Seiko Epson Corporation
Microdevices Operations Division

Notification of Exterior Finish Change for Quartz Accelerometer / Vibration Sensor

Figure 1 Height of the g section on the connector surface

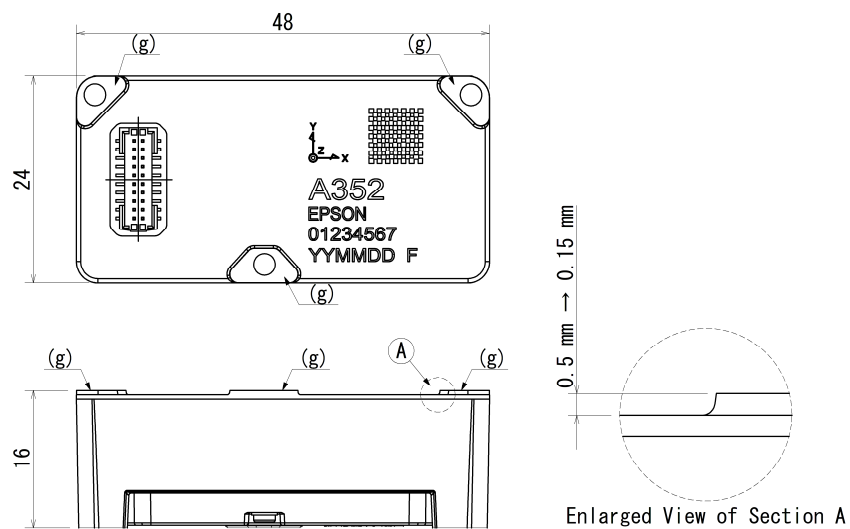
The height of the g section on the connector surface will be changed, and the laser marking on the base will be discontinued.

Part	Item	Current	New
Housing (Case)	Surface finish	Painting (blue)	Nickel plating
	Height of g section on connector surface See Fig. 1 for details	0.5 mm	0.15 mm
Housing (Base)	Surface finish	Painting (black)	Nickel plating
	Laser marking	Yes	None
